Type of Report:	Committee
Council:	19 December 2016
Expiry Date:	19 December 2016
Application No:	PLN-16-768
Address:	379 ELIZABETH STREET , NORTH HOBART 367 - 375 ELIZABETH STREET , NORTH HOBART 29 STRAHAN STREET , NORTH HOBART 31 STRAHAN STREET , NORTH HOBART ADJACENT ROAD RESERVE
Applicant:	David Johnnton (Circa Morris-Nunn Architects) 27 Hunter Street
Proposal:	Partial Demolition, Alterations and Extensions to Existing Buildings, New Development for Business and Professional Services, General Retail and Hire, Multiple Dwellings, and Community Meeting and Entertainment, Signage, Change of Operating Hours, Changes to Parking and Access, an Works in Road Reserve
Representations:	One (1)
Performance criteria:	General Business Zone Use and Development Standards, Parking and Access Code, Historic Cultural Heritage Code, Signs Code and North Hobart Specific Area Plan

- 1.1. Planning approval is sought for 'partial demolition, alterations and extensions to existing buildings, new building for business and professional services, general retail and hire, three multiple dwellings, and community meeting and entertainment, signage, change of operating hours, changes to parking and access,

Image 6. Excerpt from 'north east rear carpark' elevation (submitted drawing 1601-DA3.01B) (Annotated by planner with height marker).

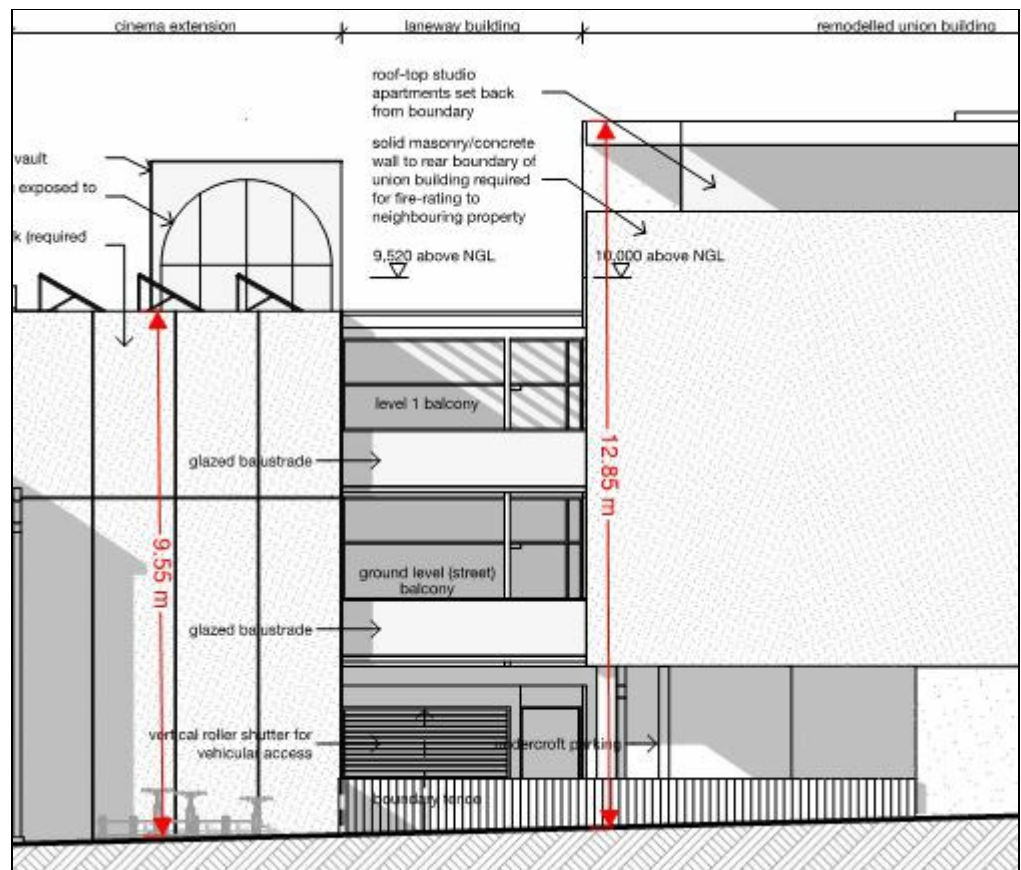
The height of the proposed Union building ('building' 3) at its north east / rear elevation is 12.8m above the shown natural ground level. The majority of this building is proposed as four levels. The existing rear maximum height of the Union building is approximately 8.8m above natural ground level (as annotated on 'South East (Strahan Street)' elevation on drawing 1601-DA3.01B).

The height of buildings 1 and 2 at the rear are proposed as maximum 9.5m above the shown natural ground level. These building are over three levels.

- 6.8.2. The Acceptable Solution at clause D21.4.1 A1 provides for a maximum building height of 9m.

6.8.5. The portion of the proposed building 3 above 9m on the Elizabeth Street elevation is acceptable given the stepped back nature of the top level. The Council's Cultural Heritage Officer has recommended that the highest portion of the 'tower' element be reduced in height to that of the proposed battened screen on building 3. Rationale for this height reduction is provided in detail in the Cultural Heritage Officer's report attached to this report and in the relevant heritage standard assessment below.

Image 11. Excerpt from submitted plan showing area of building where a higher solidity of facade is recommended to be required by condition.

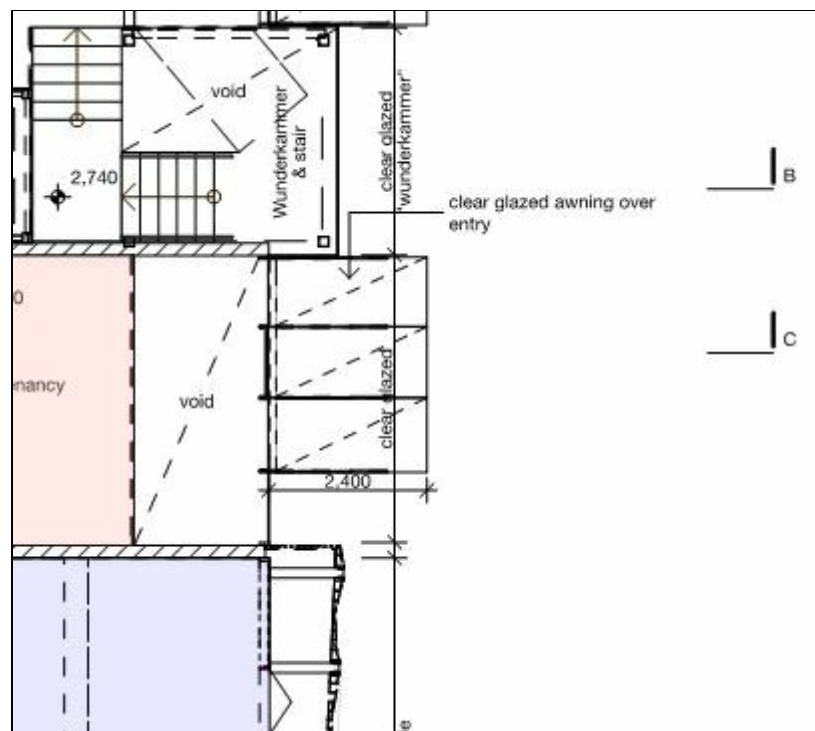
The 'tower' with glazed elements either side is inconsistent with the characteristic solid to void ratio. The first floor level facade of the setback component (to the north west of the 'tower' element, labelled 'void' on plan), is required to have a void to wall face ratio more consistent with prevailing character at first floor level. A condition to this effect has been included.

The glazed front elevation of 'building 2' must be redesigned to show the void (opening) to solid (wall) ratio more consistent with void to solid ratio prevailing in the streetscape at first floor level.

Design drawings must be submitted and approved, prior to the issuing of any permit under the Building Act 2000. The amended drawings must include details of how this increased solidity will be achieved, to satisfy the above requirement. All work required by this condition must be undertaken in accordance with the approved drawing.

Image 13. The facade and awning of the Union building at 379 Elizabeth Street would be removed from the streetscape.

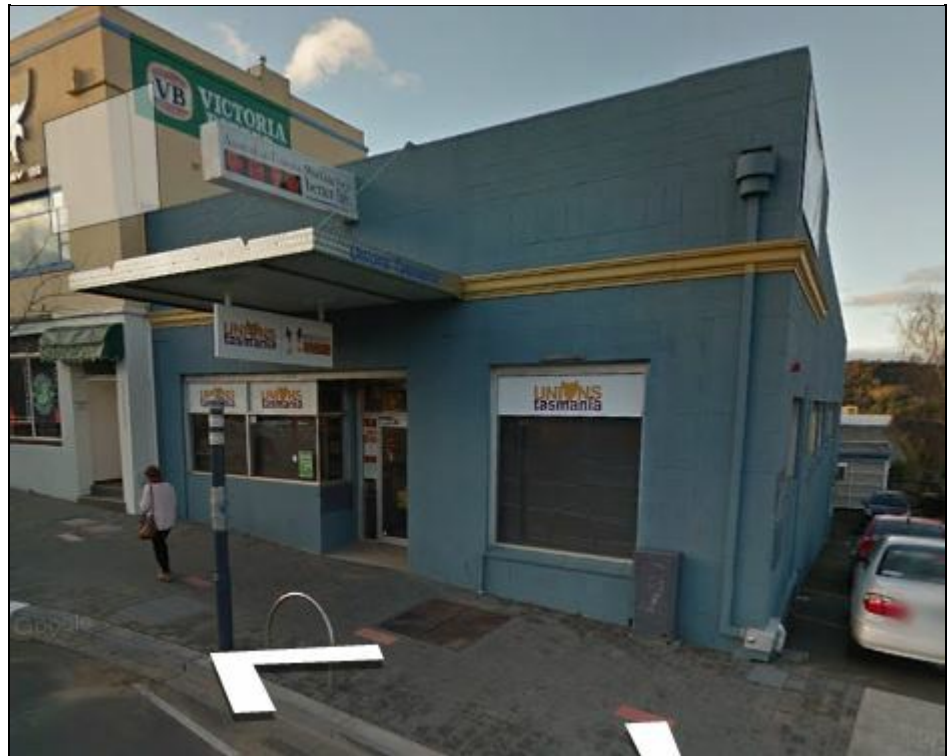
6.27.1. The awning on the existing Union building would be removed from the streetscape. Three glazed awnings are proposed along the new building frontage as well as the floating battened screen on building 3 that would have a semi-awning purpose in its contribution to the streetscape although not as a pedestrian shelter. The northern-most awning over the entry was to the rear tenancies and the residential units of building 3 is proposed with a height above the footpath within the lot boundary of 2.4m.
